Access Compliance Report

Public Rights-of-Way

| Intersection ID: 45245 | Main Street: KODIAK_CT | Cross Street: BRIGHTFALLS_WY | Location: SE |
| ADA ID: 53B8ED121E28 | Ramp Type: Perp | Initial Pass/Fail: Fail | Overall Compliance: No |

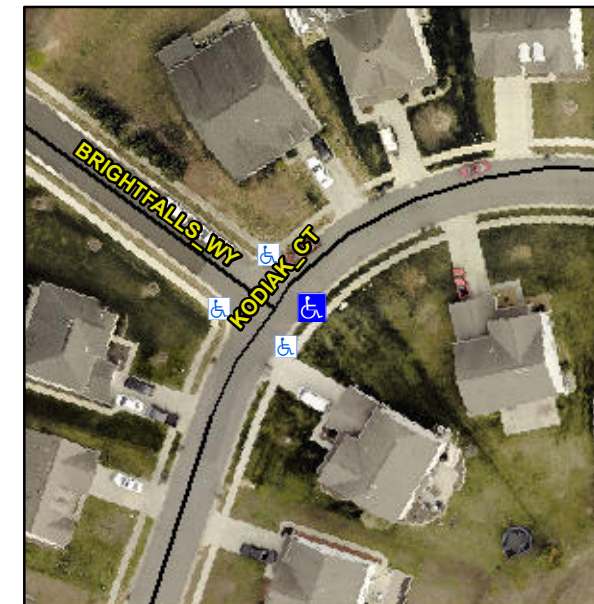
Not Found, R304.5.1, R304.2.2, R304.5.3

| Compliance | Description | Data | Compliance | Description | Data |
|------------|-----------------------|-------|------------|-----------------------------|------|
| N/A | Ramp Length (in) | 47.5 | No | Ramp Slope (%) | 10.5 |
| No | Ramp Width (in) | 47.5 | No | Ramp XSlope (%) | 3.9 |

Remove & Replace Entire Ramp.
